***Development Special Use Permit #2016-0007
5000 and 5001 Echols Avenue
Fillmore / St. James Phasing Amendment***

Staff Recommendation: APPROVAL WITH CONDITIONS

The applicant requests approval of an amendment and update to standard conditions of previously-approved Development Special Use Permit #2014-0003 to allow the construction of two multifamily residential buildings (a 93-unit affordable housing building and 132-unit market rate building) and associated improvements to proceed in separate construction phases.

Emergency Vehicle Easements

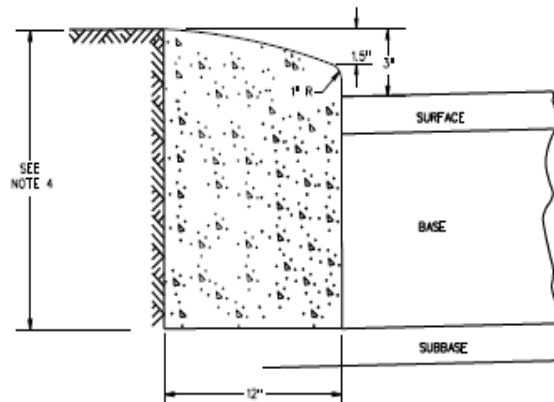
Emergency Vehicle Easements. Emergency vehicle easements shall be a minimum of 22 feet across the travel lane. The emergency vehicle easement shall provide access to strategic areas of the building and fire protection systems. Curbing and street components shall conform to the standards established by Transportation and Environmental Services and this document for emergency vehicle easements.

Sign Specifications. Emergency vehicle easement signs shall be metal construction, 12-inches wide and 18 inches in height. Provide red letters on reflective white background with a $\frac{3}{8}$ -inch red trim strip around the entire outer edge of the sign. The lettering shall say "NO PARKING," "EMERGENCY VEHICLE EASEMENT," "EM. VEH. EAS," and "City of Alex.," Lettering size shall be as follows: "NO PARKING" - 2 inches, "EMERGENCY VEHICLE EASEMENT" - 2½ inches. EM. VEH. EAS. - 1 inch, CITY OF ALEX. - ½ inch. Directional Arrows - 1 inch by 6 inches solid shaft with solid head - 1½ inches wide and 2 inches deep (For examples, see Figures D102.1, D102.2, and D102.3). Signs shall be mounted with the bottom of the sign 7 feet above the roadway, and shall be properly attached to a signpost or other approved structure such as designated by the fire official. Posts for signs, when required, shall be metal and securely mounted. Signs shall be parallel to the direction of vehicle travel and posted so the directional arrows clearly show the boundaries and limits of the Emergency Vehicle Easement. In areas where emergency vehicle easements involve two-way traffic, double mounted signs shall be provided. The maximum distance between signs shall be 100 feet. Other special signs or modifications to emergency vehicle easement signs shall be approved by the fire official.

MODIFIED 3" CURB

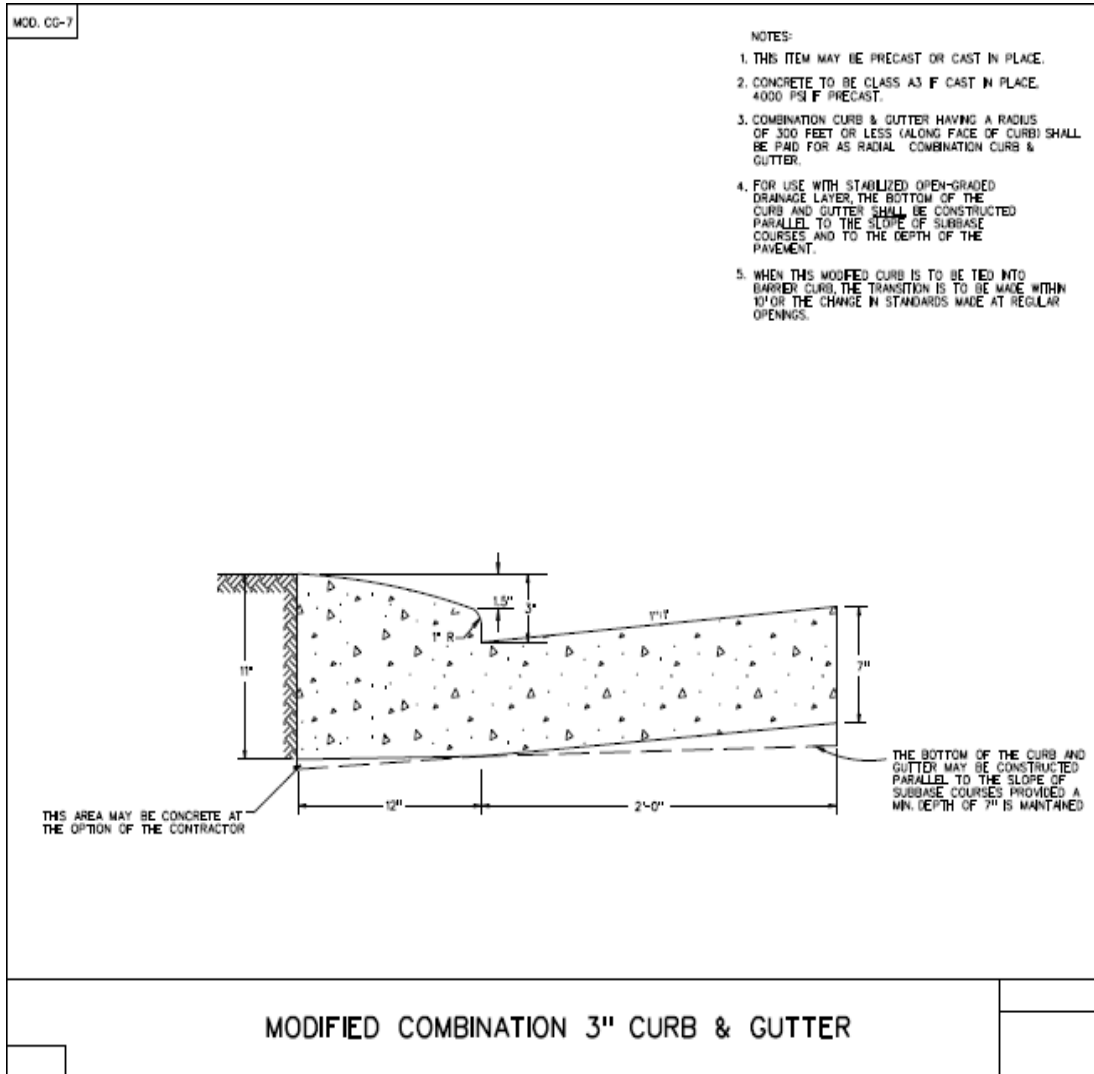
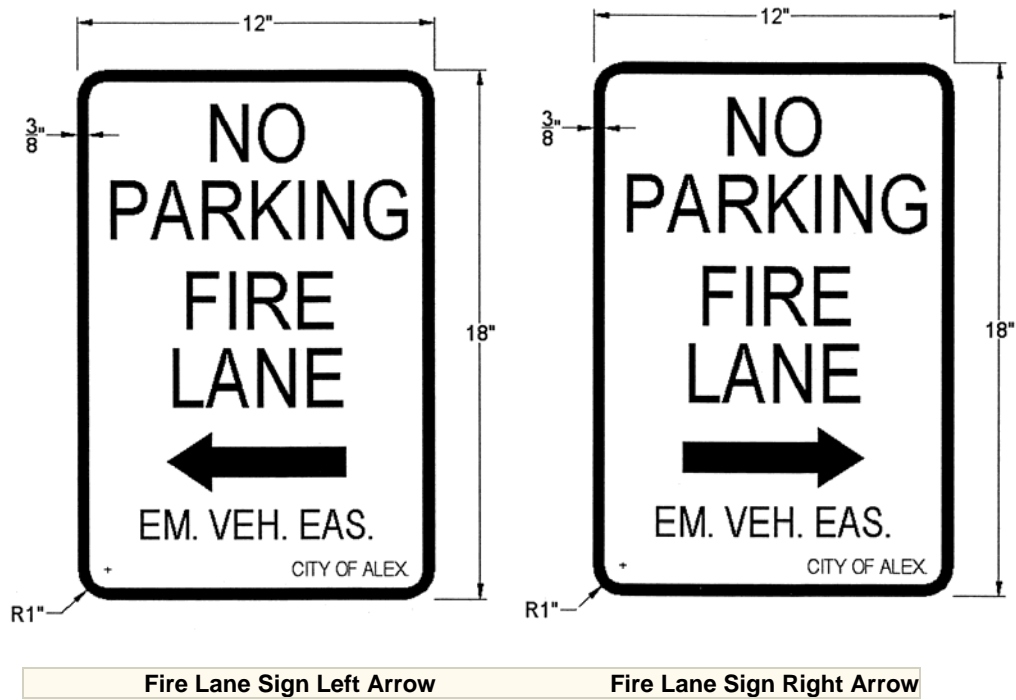
Fire Dept. Access Lanes/Mountable Curbs. Where curbing is a component of the emergency vehicle easement, the curbing construction shall conform to weight and grade requirements for vehicular traffic. In no circumstances shall a raised curb be located in the path of travel in an emergency vehicle easement. Where a mountable curb is provided as part of an emergency vehicle easement, emergency vehicle easement signs shall be posted at the point nearest the edge of the emergency vehicle easement, but in no case within the clear width of the emergency vehicle easement.

Applicant indicates a mountable curb will be installed at "T". One of the above design shall be used for the curb. Will be on final site plan.

Tower 203 Turning Specifications

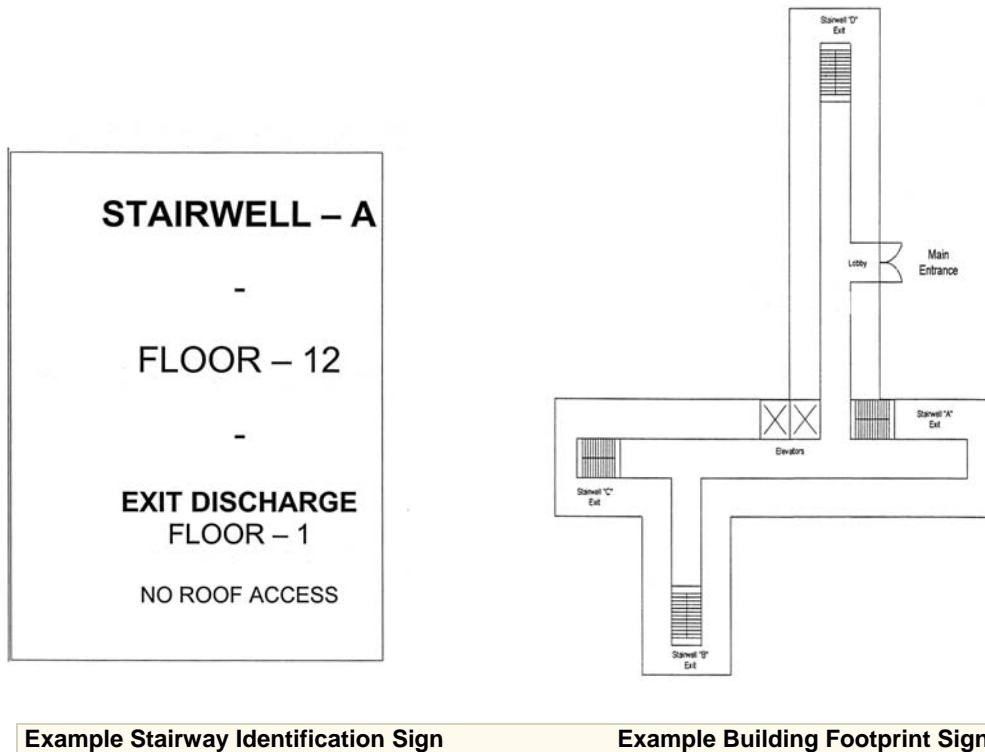
C-8 Show fire apparatus vehicle turning radius based on the following specifications:

- Turning Radius – Wall to Wall = 54.98 feet + / - 2 feet
Curb to Curb = 51.33 feet + / - 2 feet
Inside turning radius = 37.73 feet + / - 2 feet
- Overall Length – 47' – 4 ½"
- Overall Width – 98"
- Wheel Bases from front axle to both rear axles – 240"
- Tandem axle spacing – 56" CL of axle to CL of axle
- Gross Weight – As built with no equipment or water gross weight = 66,000#
- Angle of Approach – 13 Degrees
- Angle of Departure – 11 degrees
- Ramp Break Over – Break over angle is 9°

Applicant previously demonstrated the turning movement at the “T” turn around.

Emergency Vehicle Easements

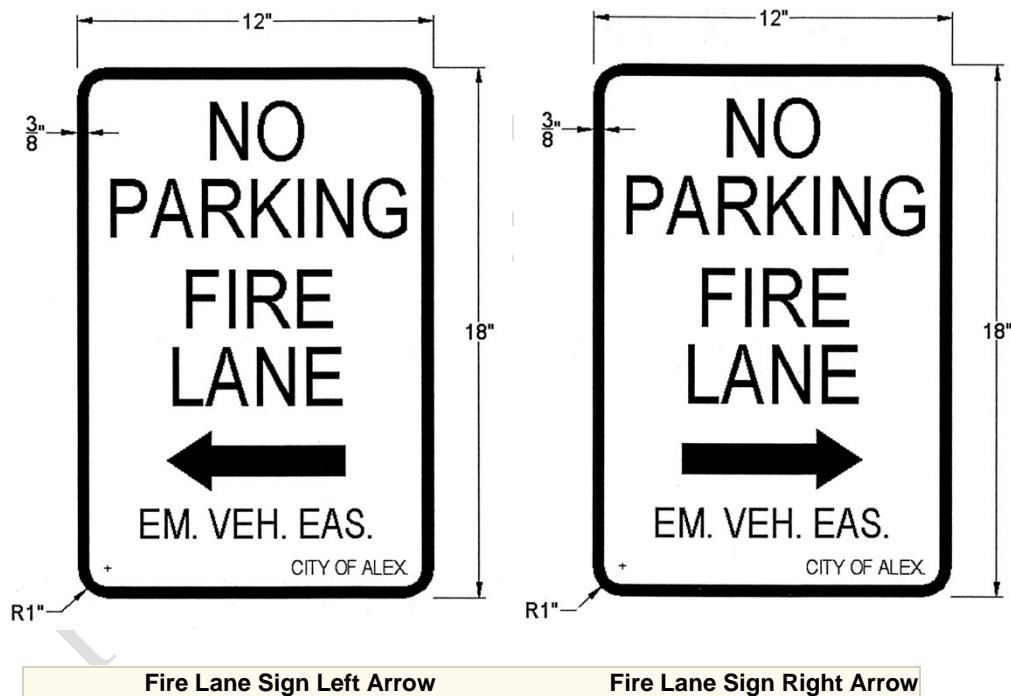
- C-7 The final site plans shall show placement of emergency vehicle easement signs. See sign detail and placement requirements below.

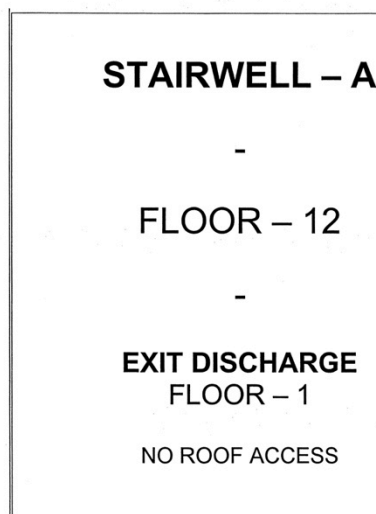
- C - 8 Per the requirements of Title 4, Chapter 2, Article B, Section 4-2-21, Appendix A, Section A 106(6), Figure A 106.1 Minimum Standards for Emergency Vehicle Access:

Applicant has demonstrated the turning movement at the "T" turn around.

Example Building Footprint Sign

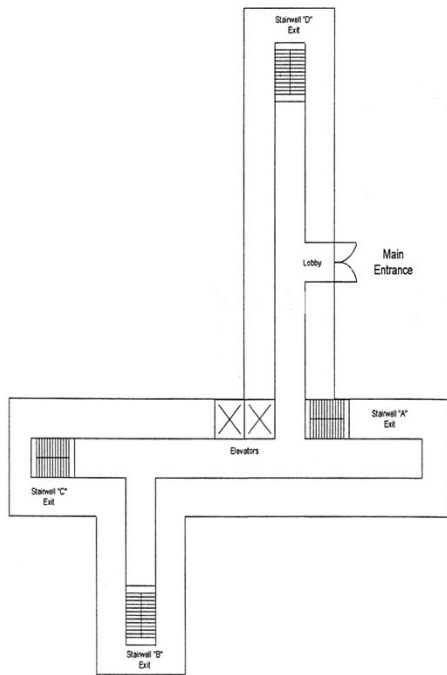
- C-9 Provide Stairway Identification. A sign shall be provided at each floor landing in interior vertical exit enclosures connecting more than three stories designating the floor level, the terminus of the top and bottom of the stair enclosure and the identification of the stair. The signage shall also state the story of, and the direction to the exit discharge and the availability of roof access from the stairway for the fire Department, in accordance with USBC 1020.1.6.

Footprint requirements. In buildings greater than three stories where there is no graphic representation of the building footprint, a simplified building schematic must be display in the lobby. The simplified building footprint shall be an overhead view of the buildings exterior and the general layout of the lobby of the first floor. Stairways shall be denoted by letter as stated in section 1020.1.6. (See Figure 1020.1.6.2)

Previously acknowledged by applicant.
